Date of Issue: August 2017

Affected Publication: API Specification 16A, *Specification for Drill-through Equipment*, Fourth Edition, April 2017

Errata 1

Section 5.3.5.2.3, Figure 9c:

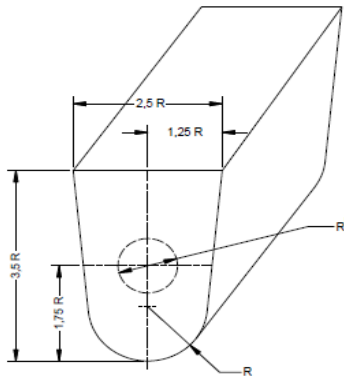
- Insert new right-most figure:
